Work Order ID 112954

Item Name: Bracket

APICAL INDUSTRIES, INC.	ENGINEERING CHANGE NOTICE NO. 03697				SHEET 1 OF 1	
	DWG NO. 646.3800	REV: N/C	PREPARED BY B. PETERS	DATE: 11/14/12	EFFECT ON DWG <input type="checkbox"/> INC. <input checked="" type="checkbox"/> UNINC.	
	DWG TITLE: BRACKETS					
	APPROVED BY: ENGR <i>[Signature]</i>	MFG <i>[Signature]</i>	QC <i>[Signature]</i>	EFF: NEXT ORDER		
TRANSACTION CODES (TC) A-ADD C-CREATE R-REVISE D-DELETE	REASON: ADDED ALTERNATE MATERIAL.				ECR: D-12-006

646.3810

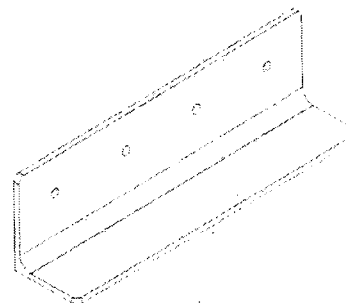
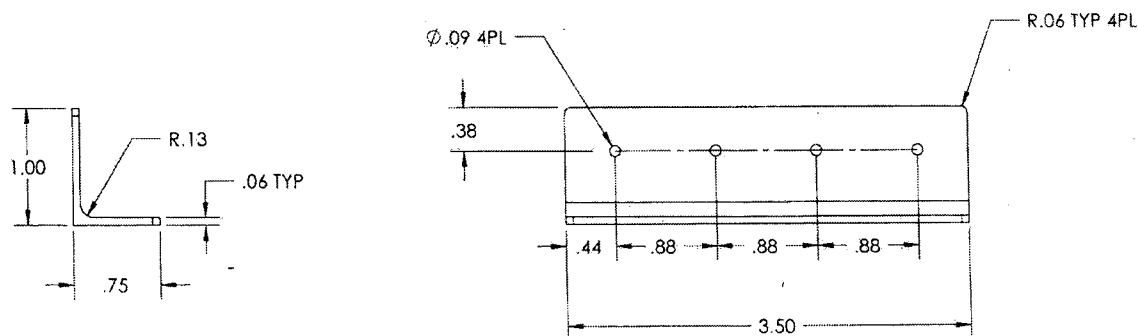
SHEET 1, ZONE A2 IS:

⚠ PRIMARY MATERIAL: 7075-T651 ALUMINUM PER AMS-QQ-A-250/12.
ALTERNATE MATERIAL: 7075-T6511 ALUMINUM PER AMS-QQ-A-200/11.
